Re: Application of ORBIMAGE, Inc.

Call Sign S2348

File No. SAT-MOD20050511-0097

DSN Filter Response

Figure 1. OV-5 DSN Filter Response

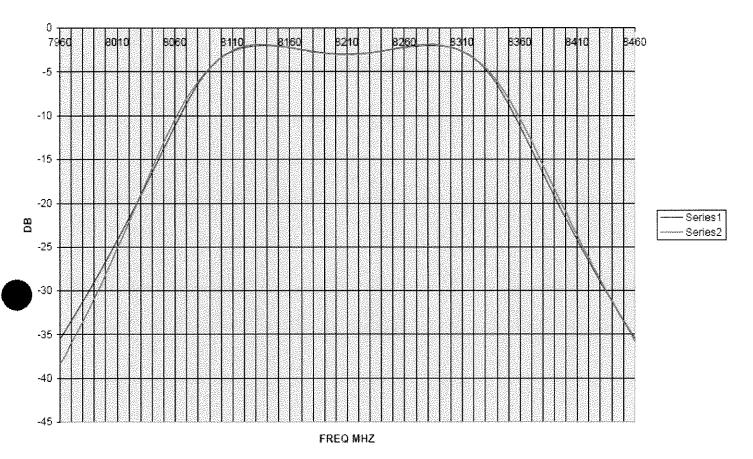
The letter indicated that further clarification and additional information was needed in order to facilitate the coordination between the Commission and NTIA. Accordingly, ORBIMAGE was asked to supply three items of information: First, the Commission requested that ORBIMAGE provide the frequency response of the filter described in Exhibit 2, Technical Annex, page 7 of the application and to explain whether these characteristics are the same as those of the current constellation. Second, ORBIMAGE was asked to provide the maximum power spectral density ("PSD") in the frequency range of 8400 MHz-8450 MHz for the Telemetry Downlink. Finally, the letter requested that ORBIMAGE provide the crossing time of the ascending node of OV-5.

In response to the first inquiry, ORBIMAGE provides the filter response in the attached Exhibit A. The OV-5 filter characteristics are not the same as those on the current constellation, OV-3. The OV-5 x-band downlink covers a wider bandwidth (370 MHz) than the OV-3 downlink (150 MHz). In addition, the OV-3 center frequency of 8190 MHz differs from the OV-5 center frequency of 8210 MHz. In response to the second inquiry, ORBIMAGE provides the maximum PSD in the attached Exhibit B.

Figure 1 shows the OV-5 DSN filter response. Series 1 is the ideal filter response and Series 2 is the actual filter response.

The following calculations show that the 370 Mbps wideband downlink meets the ITU Recommendation ITU-R SA.1157 Protection Criteria for Deep-Space Research with at least 6.85 dB of margin.

Actual filter attenuation @ 8400 MHz = 21 dB

Margin @ 8400 MHz = 15.31 dB

Required filter attenuation @ 8410 MHz = (37.29 dB) + (-22.59 dB) Required filter attenuation @ 8410 MHz = 14.70 dB Actual filter attenuation @ 8410 MHz = 24 dB

Margin @ 8410 MHz = 9.30 dB

Required filter attenuation @ 8420 MHz = (37.29 dB) + (-18.75 dB) Required filter attenuation @ 8420 MHz = 19.15 dB Actual filter attenuation @ 8420 MHz = 26 dB

Margin @ 8420 MHz = 6.85 dB
